SUBJECT: Forwards rev 19 to "KNPP Operational QA Program Description," IAW requirements of 10CFR50.54(a)(3). Revs have strengthened program, clarified util commitments & incorporated changes in util organization.

Docket 50-305
Operating License DPR-43
Kewaunee Nuclear Power Plant
Revision 19 of the Operational Quality Assurance Program Description

Description of Revisions to the Kewaunee Nuclear Power Plant

Revision 19

Figure 1 Quality Assurance Organization - Oversight Function

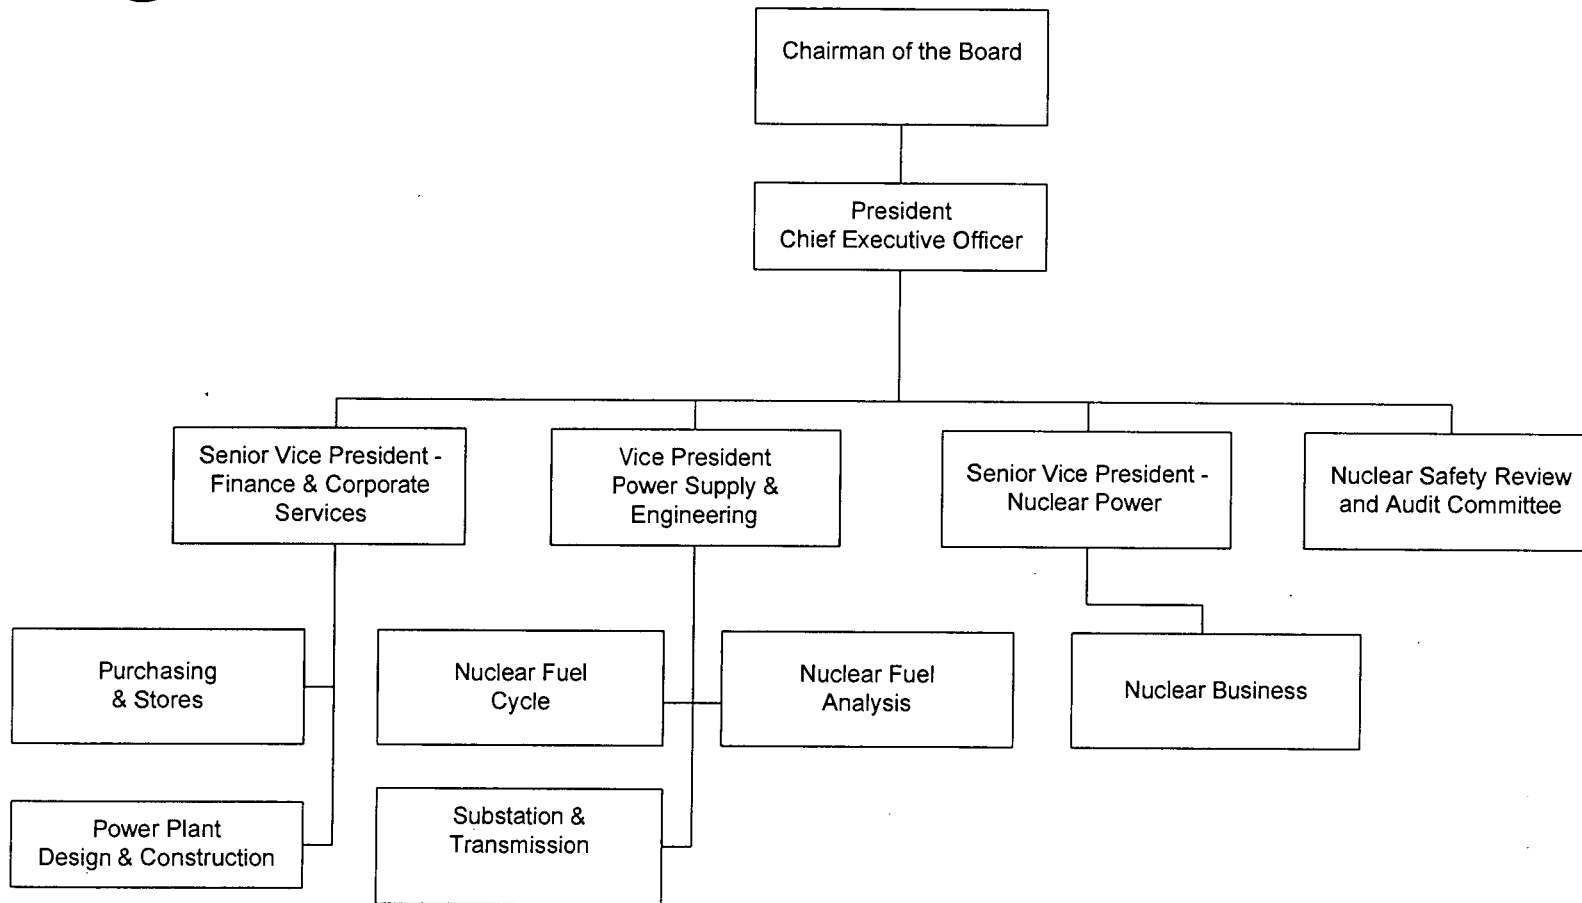
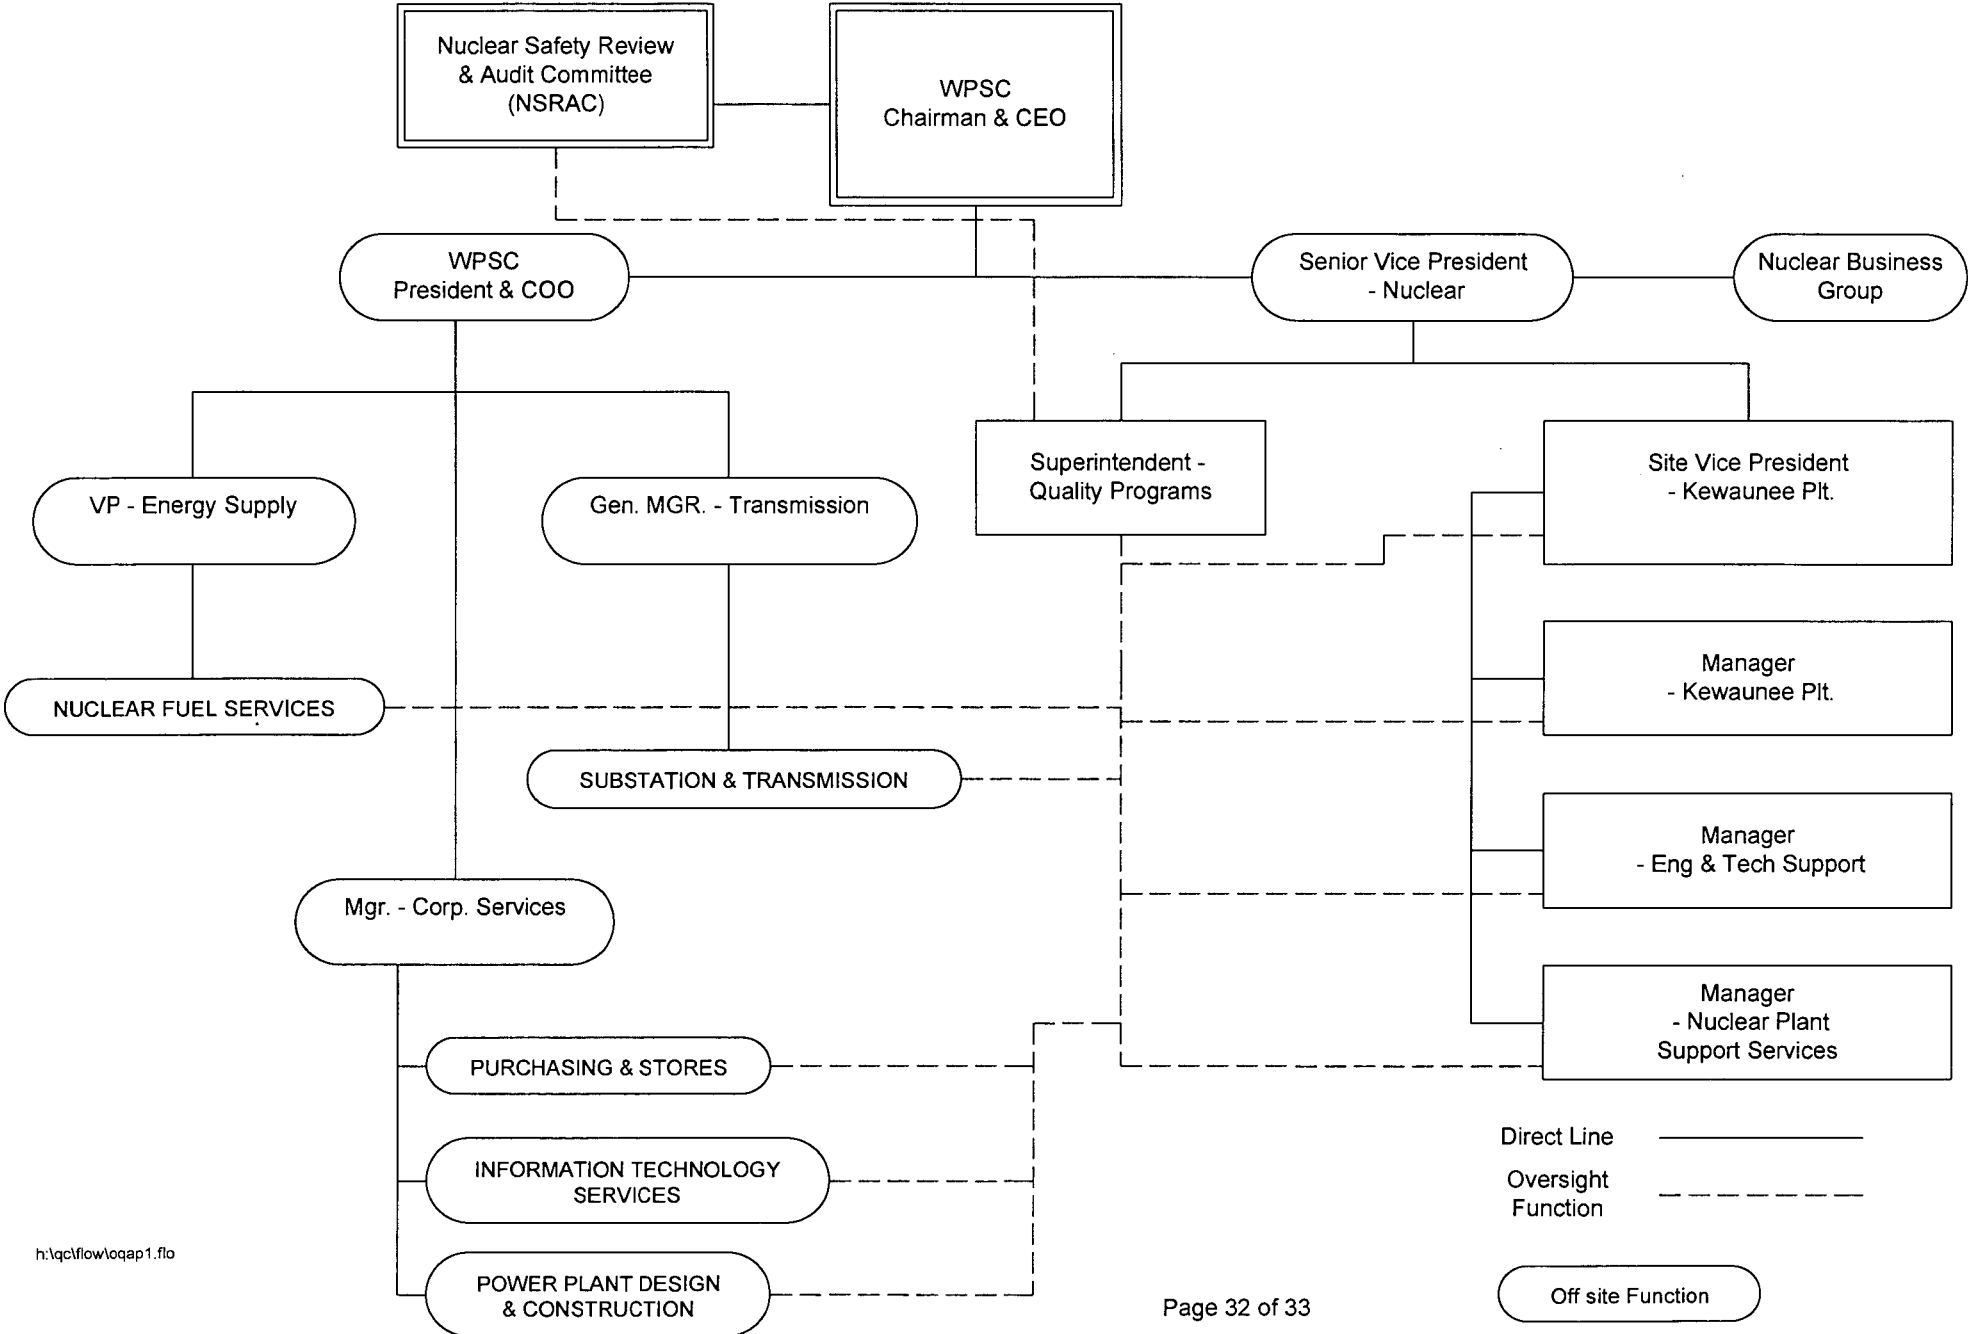
Figure 1 is changed in total.

Reflect the current WPSC organization to show direct line and the quality oversight function.

Figure 2 Nuclear Power Production Organization & Quality Assurance Organization

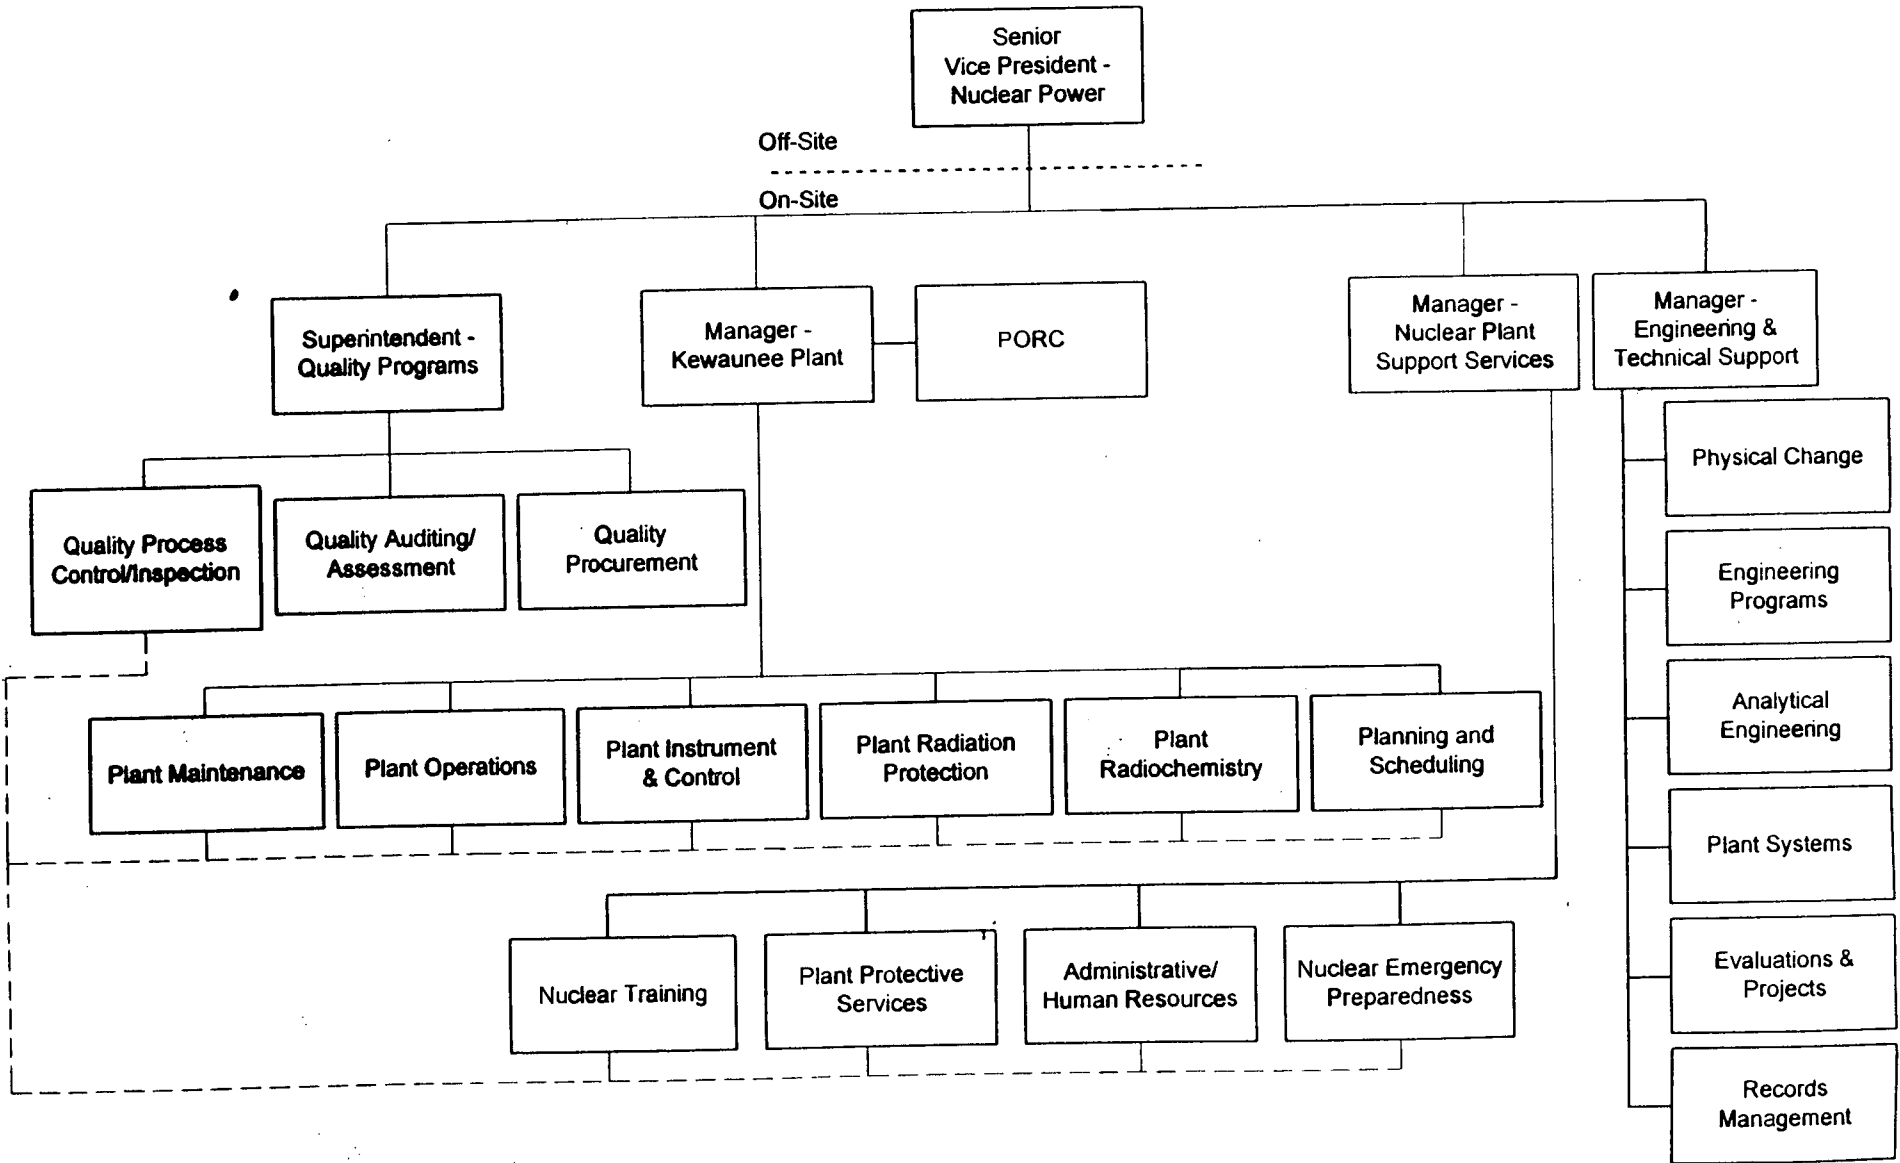
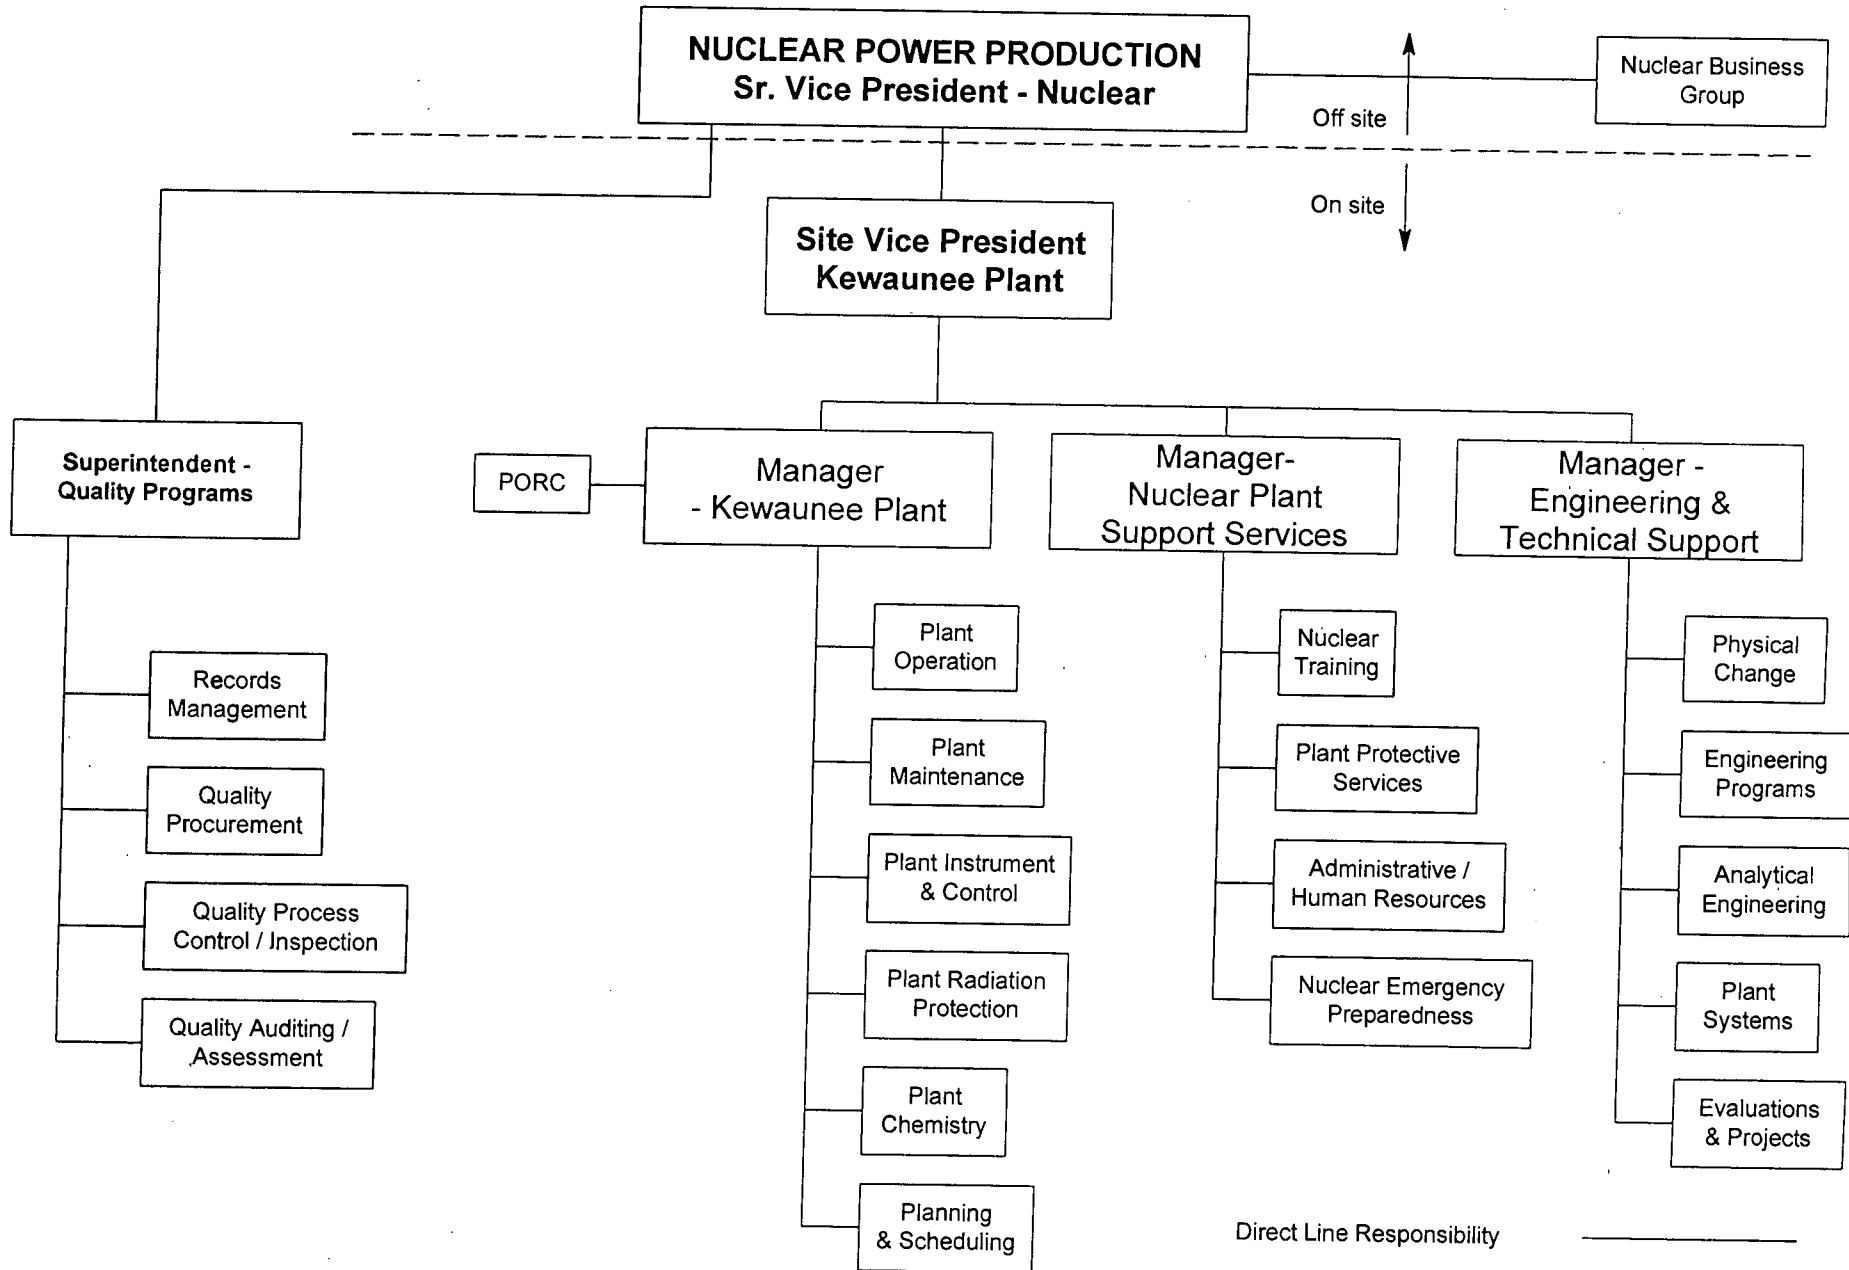
Figure 2 is changed in total. Removed lines reflecting "Communication/Coordination"

Reflect the current Nuclear Power Production organization. The Quality Programs oversight function is reflected on Figure 1, Page 32 of 33.
